P5021A-03-S

Safety Service Note

P5021A Keysight Streamline USB Vector Network Analyzer

“POTENTIAL BURN INJURY (HIGH TEMPERATURE) HAZARD”

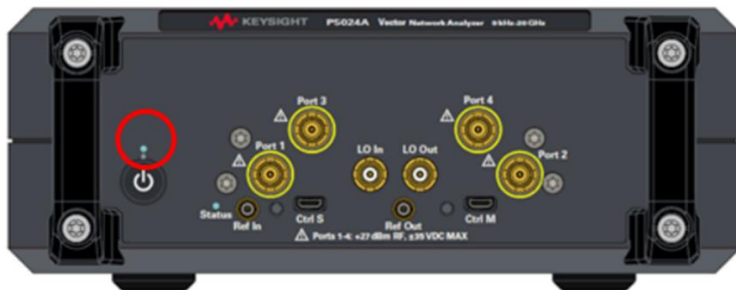
Symptom:

VNA fails to start with the following symptoms.

1. LED indicator (below circle) turns red.
2. cooling fan does not work
3. If user leaves the VNA with this LED indicator red without turning off power switch, it continues to overheat and becomes too hot.

Solution-1: Update VNA firmware by user

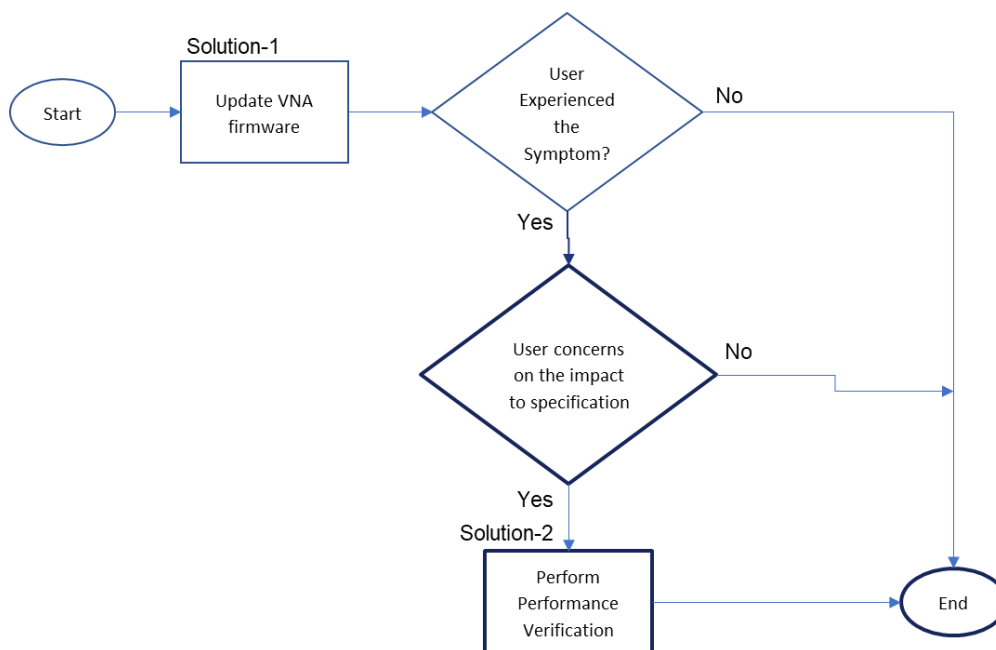
Earlier versions of firmware have potential risk of overheating, due to thermal fan control malfunction.

Action-1: Updating the firmware eliminates this potential risk of overheating.

1. **Install the latest VNA firmware Rev. A.15.40.13 or newer on users' controller PC(s).**
The latest firmware enhanced the thermal fan control mechanism.
2. Once the latest firmware is installed, proceed with the restart of both **controller PC** and **VNA**.
3. Launch the VNA firmware. Ensure VNA powers up and launches into firmware correctly after firmware update is done.
